Access Compliance Report

Public Rights-of-Way

(Curb Ramps)

Intersection ID: 10029688	Main Street: KINGSLEY_VIEW_DR	Cross Street: N/A	Location: SE
ADA ID: 5460A553F545	Ramp Type: PerpDiag	Initial Pass/Fail: Fail	Overall Compliance: No
Codes/Mitigation Info/Possible Solution		Field Measurements/Component Compliance	
Severity Score: 25

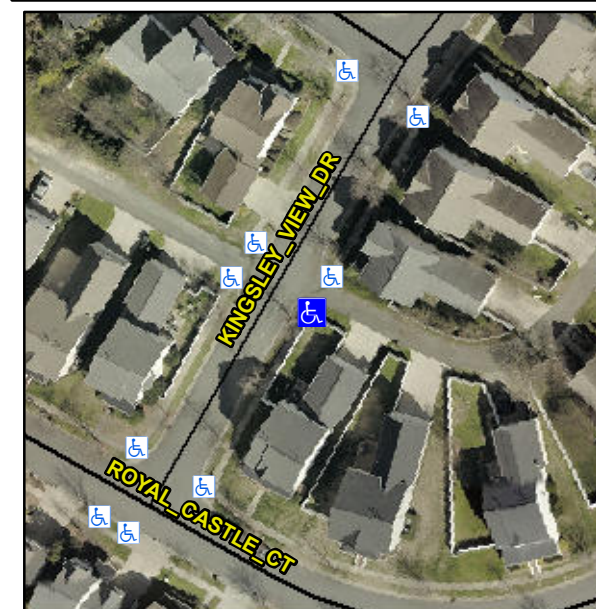
R304.5.3

Compliance	Description	Data	Compliance	Description	Data
N/A	Ramp Length (in)	36.0	Yes	Ramp Slope (%)	6.1
Yes	Ramp Width (in)	48.0	No	Ramp XSlope (%)	9.6
N/A	Flare Type LT	N/A	N/A	Flare Type RT	N/A
N/A	Flare Slope LT (%)	N/A	N/A	Flare Slope RT (%)	N/A
N/A	Flare Traversable LT?	N/A	N/A	Flare Traversable RT?	N/A
N/A	Landing Length (in)	N/A	N/A	DWS Provided?	N/A
N/A	Landing Width (in)	N/A	N/A	DWS Contrast?	N/A
N/A	Landing Slope (%)	N/A	N/A	DWS Length (in)	N/A
N/A	Landing X Slope (%)	N/A	N/A	DWS Full Width?	N/A
N/A	Landing Curb? (Y/N)	N/A	N/A	DWS Offset (in)	N/A
N/A	Shared Landing?	N/A			
N/A	Gutter Ponding?	N/A	N/A	Gutter Slope (%)	N/A
N/A	Gutter Lip Ht (in)	N/A	N/A	Gutter X Slope (%)	N/A
N/A	Painted X Walk1?	No	N/A	Painted X Walk2?	No
	X Walk 1 Direction	To NE		X Walk 2 Direction	To NW
N/A	X Walk 1 Width (in)	N/A	N/A	X Walk 2 Width (in)	N/A
	X Walk 1 Slope (%)	3.1		X Walk 2 Slope (%)	4.0
	X Walk 1 X Slope (%)	4.2		X Walk 2 X Slope (%)	8.4

Remove & Replace Curb Ramp With Two New Directional Ramps or Equivalent.
